Access Compliance Report

Public Rights-of-Way

(Curb Ramps)

Intersection ID: 14294	Main Street: EAST_BV	Cross Street: EUCLID_AV	Location: NE
ADA ID: 600D19551557	Ramp Type: Directional1	Initial Pass/Fail: Fail	Overall Compliance: No
Severity Score: 37.5			
Codes/Mitigation Info/Possible Solution		Field Measurements/Component Compliance

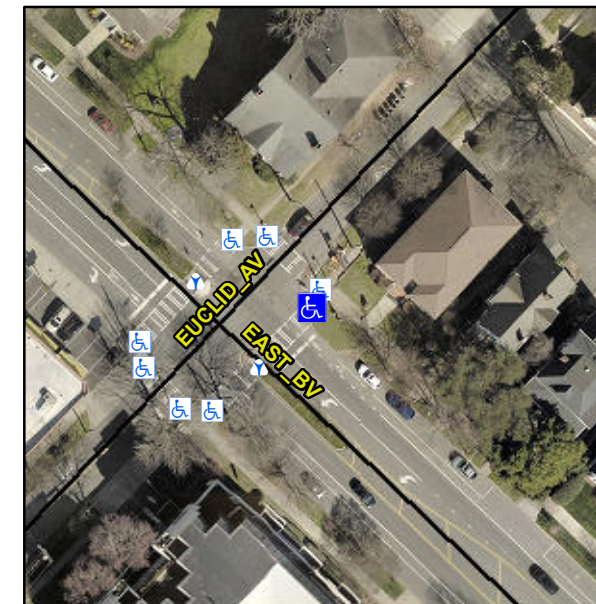
R304.2.2, R304.5.3

Compliance	Description	Data	Compliance	Description	Data
N/A	Ramp Length (in)	24.5	N/A	Grade Break?	N/A
Yes	Ramp Width (in)	64.0	N/A	Grade Break Slope (%)	0.0
No	Ramp Slope (%)	14.4	N/A	Grade Break XSlope (%)	0.0
No	Ramp XSlope (%)	5.6			
N/A	Flare Type LT	N/A	N/A	Flare Type RT	N/A
N/A	Flare Slope LT (%)	N/A	N/A	Flare Slope RT (%)	0.0
N/A	Flare Traversable LT?	N/A	N/A	Flare Traversable RT?	N/A
N/A	Landing Length (in)	0.0	N/A	DWS Provided?	N/A
N/A	Landing Width (in)	0.0	N/A	DWS Contrast?	N/A
N/A	Landing Slope (%)	0.0	N/A	DWS Length (in)	N/A
N/A	Landing X Slope (%)	0.0	N/A	DWS Full Width?	N/A
N/A	Landing Curb? (Y/N)	N/A	N/A	DWS Offset LT (in)	N/A
N/A	Shared Landing?	N/A	N/A	DWS Offset RT (in)	N/A
N/A	Gutter Ponding?	0.0	N/A	Gutter Slope (%)	N/A
N/A	Gutter Lip Ht (in)	0.0	N/A	Gutter X Slope (%)	N/A
N/A	Painted X Walk1?	Yes		Road Slope (%)	3.9
	X Walk 1 Direction	To SW		Road X Slope (%)	0.3
	X Walk 1 Width (in)	110.0		Clear Space?	N/A

X Walk 1 Slope (%)	3.9	N/A	Clear Space to XWalk (in)	N/A
	X Walk 1 X Slope (%)	0.3	N/A	Storm Grate/Utility Hazard?	N/A
N/A	Ramp inside XWalk1?	Yes		Storm Grate/Utility Type	
N/A	Any Obstructions?	N/A			N/A
	Obstruction Type		Yes	Surface Condition? (G/P)	Good
			N/A	Curb Slope (%)	10.8

Remove & Replace Entire Ramp.
